[MPC Comment] MPC Agenda Item #8: The Cove in West Hills

[MPC Comment] 9-SB-18-C_9-E-18-UR (The Cove in West Hills)

THE COVE IN WEST HILLS

Summary Report of Engineering Study of the Storm Water Management on the Proposed Site of The Cove in West Hills

Site Plan of Proposed 58 Unit Development Submitted with MPC applications

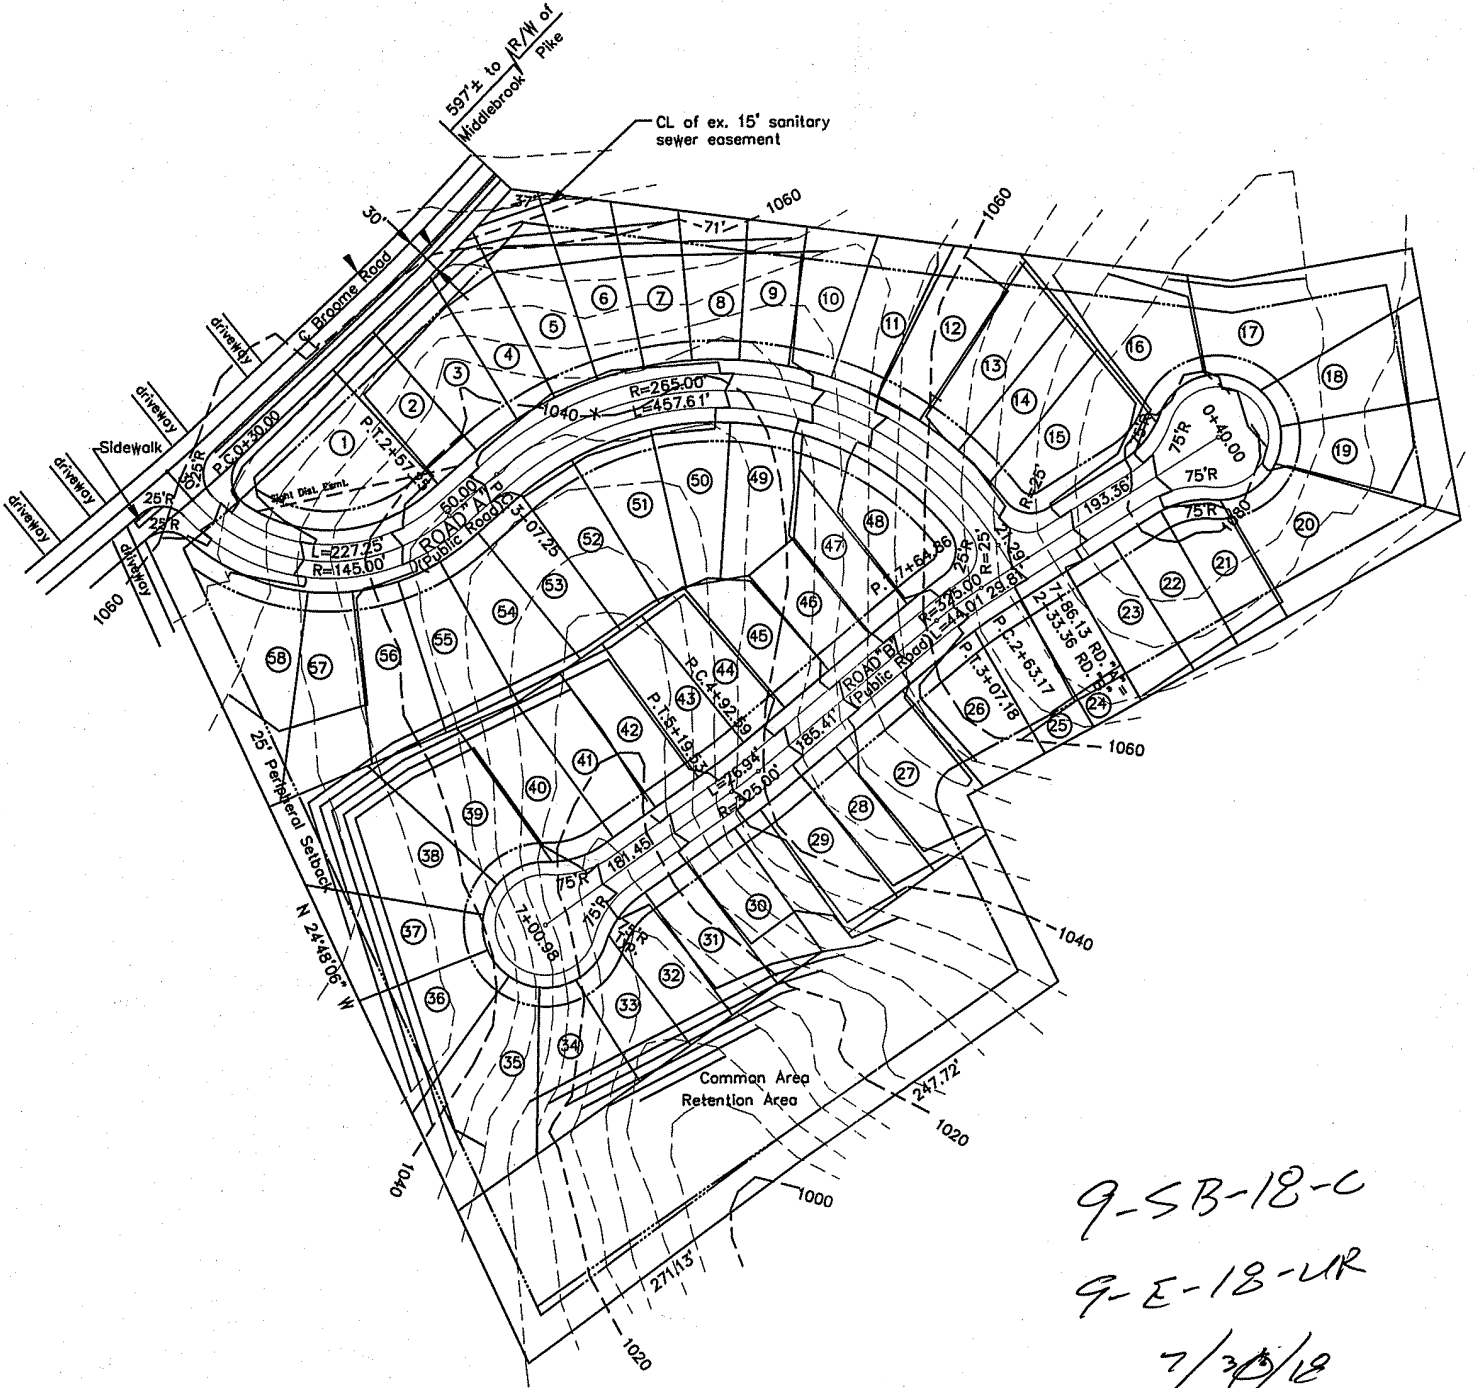
The site for the current proposed development is a 12.5 acre, deeply wooded hillside that is bisected by a natural drainage valley. The elevation of the land varies from 1065 on the north border along Broome Road to 998 at the low point on the south property line. The property's high point is 1085 on the east. See attached color-highlighted site plan.

The site plan reflects no details on how storm water management will be accomplished other than the designation of a rectangular area in the southwest corner of the property. WHCA commissioned a professional engineering firm, Geosyntec, in February of this year to conduct a storm water management study when another proposal was under consideration. The study contrasted existing conditions with the then 45-single family houses proposed in this earlier plan. Interestingly, the two site plan street layouts are identical. The later version slightly modifies the steepness of the road profiles and the number of structures changed from 45 to 28 duplex and triplex structures. See attached comparison of site plans. Both proposals can only be executed by clear-cutting the site and removal all old growth trees and existing underbrush which currently mitigate runoff.

FOR CONSIDERATION: The Concept Plan shows a “Common Area/Detention Area” near the low point of the site. The WHCA requests confirmation from the developer that a stormwater basin is intended for this space. If so, the developer must be able to design the stormwater basin in accordance with the guidelines presented herein.

FOR CONSIDERATION: Based on our review of the Concept Plan for The Cove, it does not appear that the following items are depicted:

- A general drainage plan (a general location referred to as “Detention Area/Common Area is shown but it is not confirmed that this location will be used for a sediment basin/stormwater retention pond, and additional drainage information, such as general flow patterns of stormwater runoff and the location of stormwater conveyances planned for the site, are not shown);
- A description of the physical characteristics of the site;
- Locations of existing structures and utilities;
- Existing drainageways;
- A list of required and proposed improvements.

- **Surface Area** - Based on the Concept Plan, it is assumed the **bottom of the basin will be approximately 440 feet by 60 feet** (26,000 square feet or 0.6 acres). The **sediment treatment surface** area, as calculated at the top of the principal spillway would be slightly larger than the bottom area and was calculated to be **450 feet by 70 feet** (31,500 sf or 0.72 acres). This meets the required minimum surface area of 0.56 acres, which was calculated by dividing the 5-year, 24-hour storm event inflow of 56 cfs by 100 (i.e., 1% of the peak inflow for the 5-year, 24-hour storm event).

- **Length to Width Ratio** - The Concept Plan shows two stormwater pipes discharging onto the northwestern and northeastern ends of the basin. **Based on the plan, it does not appear a 4 to 1 length width ratio could be achieved as flow paths would short-circuit the basin.** The developer may modify the plans as their design progresses by constructing baffles, moving the discharge locations, or modifying the shape of the sediment basin.
